Office Action Summary

08/464,034

HYATT, GILBERT P.

DETAILED ACTION

Office Action Figure A – Diagram of the Example Claim

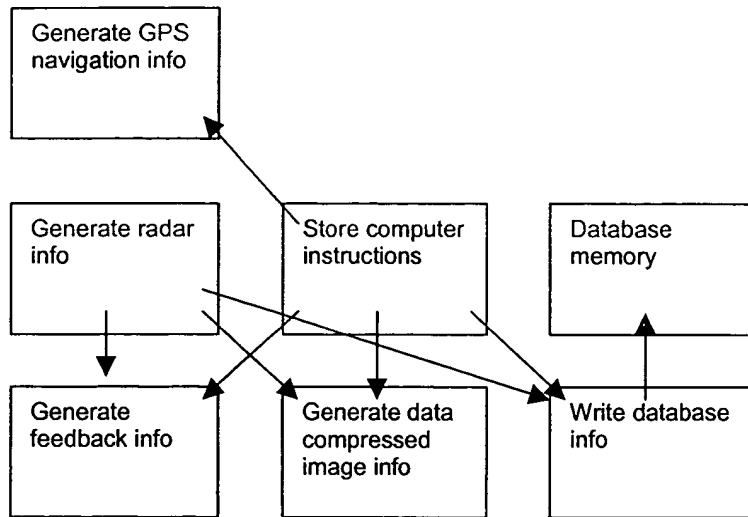
To begin with, and regarding the example claim, the examiner has diagrammed the claimed elements along with their interrelations in figure A below. The individual elements are depicted as boxes, and the interrelations are depicted as arrows spanning the boxes (i.e., not unlike the applicant's block diagram format; e.g., figure 1A).

There are no drawings that even remotely depict such a system. Neither the combination individual elements nor the interrelations between the elements are depicted anywhere. For example, according to the original specification, applicant's figures 1A and 1C depict the disclosed invention in block diagram form. That is, page 5 of the applicant's specification page describes these figures as follows:

Office Action Figure A1 – Applicant's Figure 1A

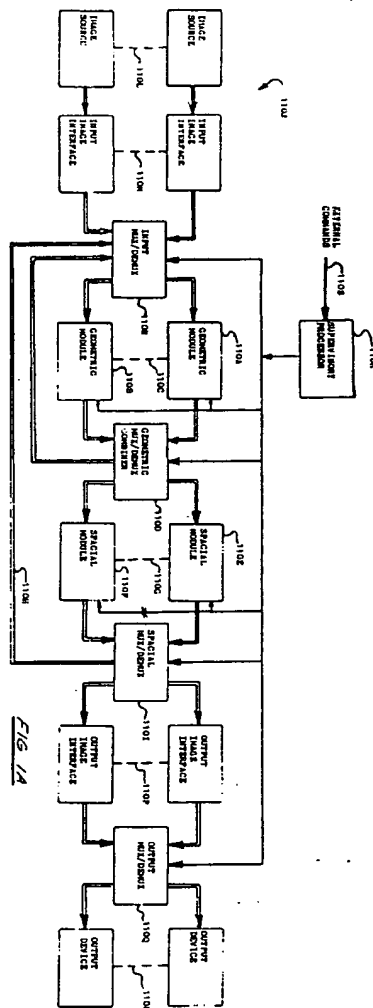
However, the applicant's figure 1A is merely a generalized, non-specific block diagram of a "system" that in no way depicts the combination of specific claimed elements, let alone the specific interrelations defined by the example claim. For

example, where in the applicant's figure 1A are the individual elements of the example claim (i.e., refer to the Office Action figure A above)? Further, where are the interrelations between the individual elements depicted? Where in the applicant's figure 1A, 1C or in any other figure is a depiction the aforementioned *combination of elements*, let alone the aforementioned *interrelations between the elements*? Upon a thorough examination of each and every figure of the applicant's original disclosure, **such** a figure cannot be found.

Office Action Figure C1 – Excerpt of Applicant's Figure 1A showing "image source"

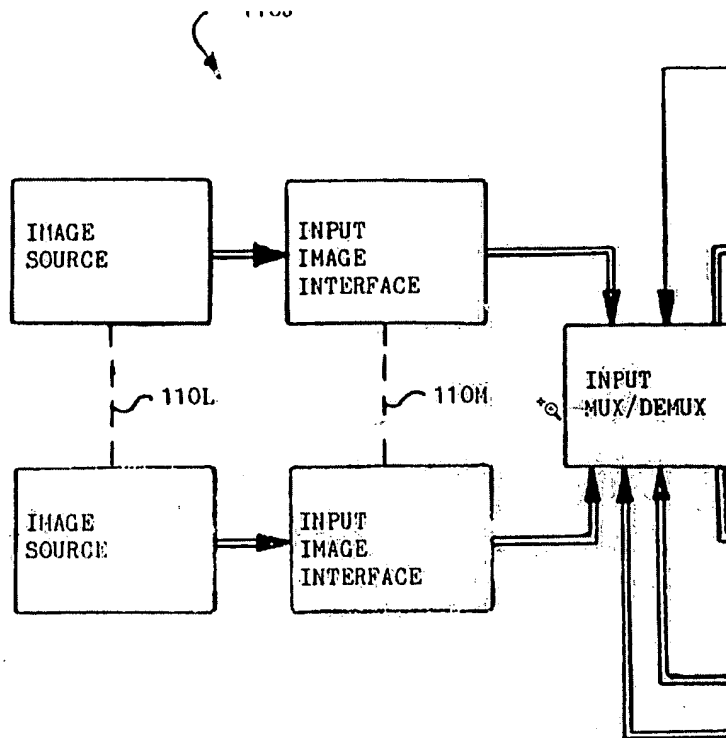
However, there is no description either in the drawing or in the specification as to the nature of the interface between the image sources and the actual image processing circuitry. While modules 110M of applicant's figure 1A are labeled as input image interfaces, the nature of the signals input thereto, or output therefrom are not described. The specification is completely silent as to the nature of the signals, let alone any timing, synchronization or control.

Office Action Figure D – Applicant's Figure 5A

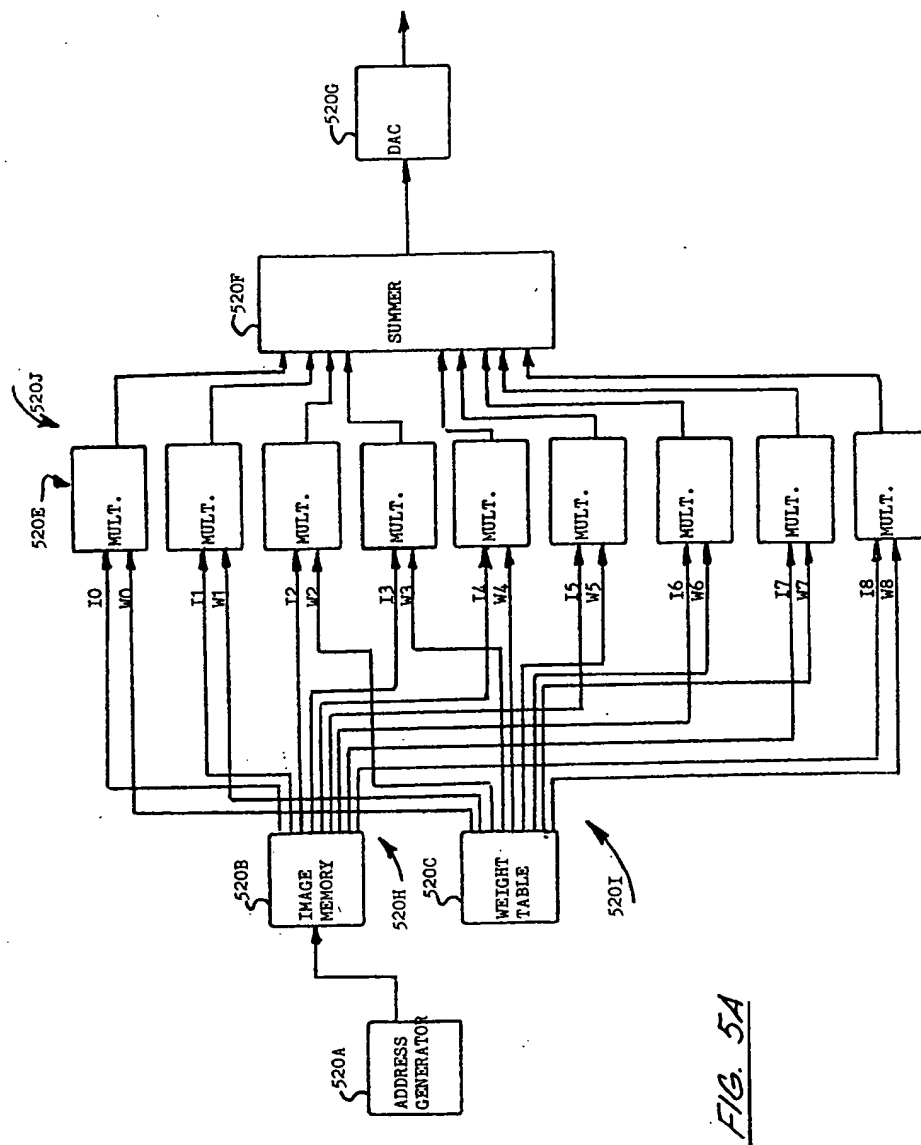
The applicant's disclosure on the other hand fails to describe the nature of any of the signals exchanged between circuits, any synchronization whatsoever, how those signals are derived, and how they are used in subsequent processing as fully described above. In order to further exemplify this, the examiner points to the applicant's figure 5A, which is similar to the figures of Billing, as follows:

Figure 5A depicts an "address generator" block connected to an "image memory", which is connected to various multipliers, a summer and a DAC. Figure 5A also depicts a

"weight table" connected to the multipliers. However, the description ends there. In stark contrast to Billing, the applicant's figure 5A does not describe the function of the address generator, the nature of the signals emanating from the address generator, how it controls the "image memory", or how the "weight table" and the "image memory" are used in the subsequent multiplications, etc. Specification pages 161-163 which describe this figure completely fail to remedy this deficiency. Nothing in these pages describes anything related to the signal format and/or synchronization between the blocks of figure 5A. Little to no guidance is provided to enable one skilled in the art to make and use the invention without undue experimentation. While this is just one example, a similar analysis of any of the applicant's figures and corresponding portions of the specification reveals the exact same deficiencies.
